**DA 2020/23 - Wollongbar District Park including  
the Skate Park - Lot 6 DP 1161720, 93 Rifle Range  
Road & Lot 39 DP 1242246, 55 Avalon Avenue,  
Wollongbar**

## Planning and Environmental Health Division Development Application Assessment

<b>Development Application No:</b>	2020/23
<b>Applicant's Name &amp; Address:</b>	Newton Denny Chapelle PO Box 1138 LISMORE NSW 2480
<b>Lodgement Date:</b>	21 January 2020
<b>Date Determined:</b>	<b>28 May 2020</b>
<b>Assessment Period (days):</b>	<b>118 days</b>
<b>Determined by:</b> <small>(under Delegated Authority – s.378 of LG Act 1993 /DAP/Council/JRPP/NSW DoP)</small>	Council
<b>Subject Land:</b>	Lot 6 DP 1161720 and Lots 39 & 45 DP 1242246, being No. 93 Rifle Range Road and No. 55 Avalon Avenue, Wollongbar (approved Lot 32 to be created via DA 2018/753)
<b>Description of Proposed Development:</b>	To establish the Wollongbar District Park including the Skate Park
<b>Building Classification under the BCA:</b>	10a amenities building 10b skate park and ancillary structures

CONCEPT DESIGN PLAN

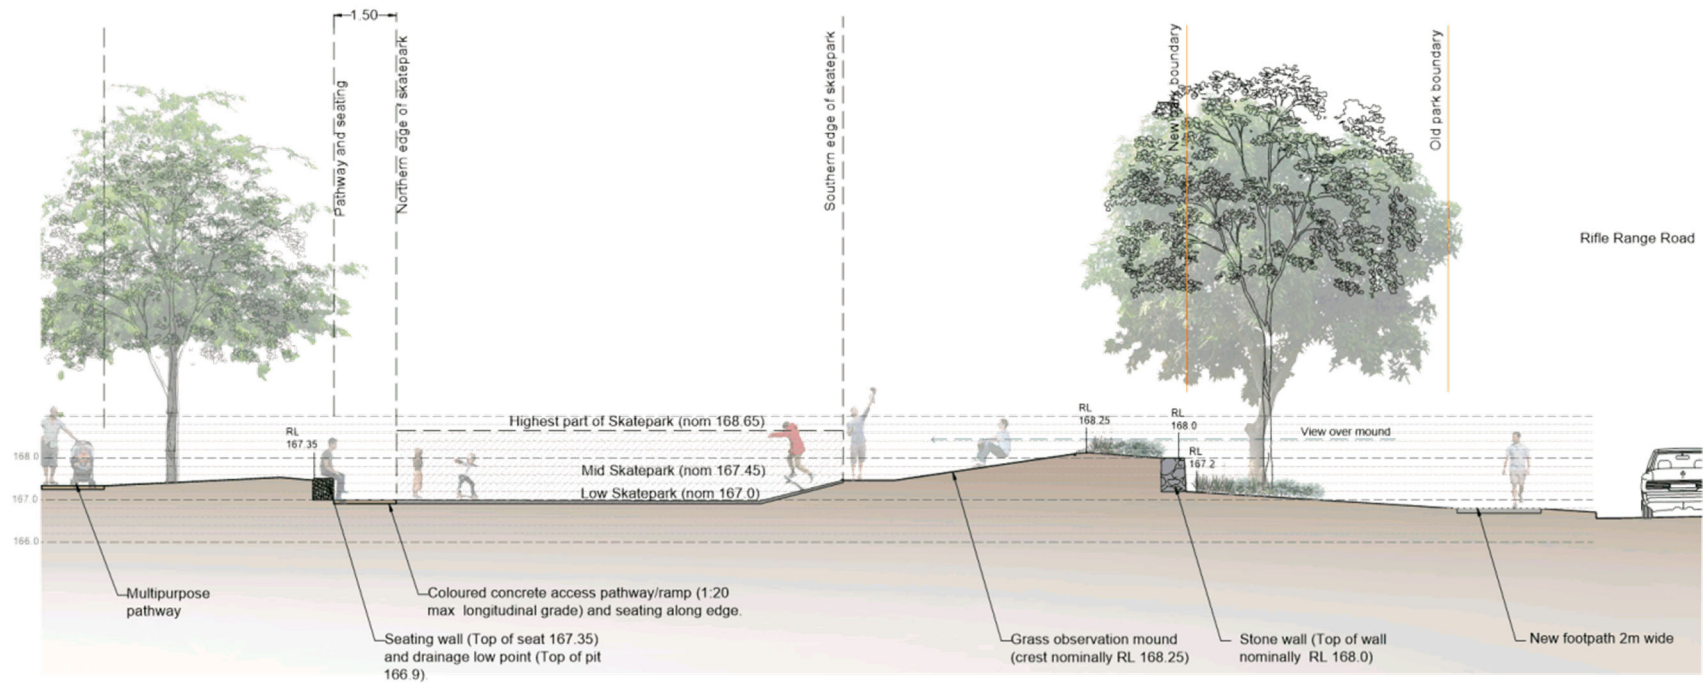
Running/Walking Track - I agree with some community members that a longer track could be achieved by having it follow the perimeter of the park more closely, to the west of the exercise area #12 and to the east of the sub-tropical rainforest planting #8 and perhaps weaving through the trees #9.

As shown on the "Concept Design Plan", there is an area of dense vegetation planting which is referenced as "8. Area 2 – Subtropical rainforest species with information signage along the pathway edge", which it has been assumed is proposed to buffer the district park and skate park from existing and future houses to the east. There are concerns that such vegetation planting will have the potential to reduce passive surveillance opportunities of the skate park when viewed from the east.
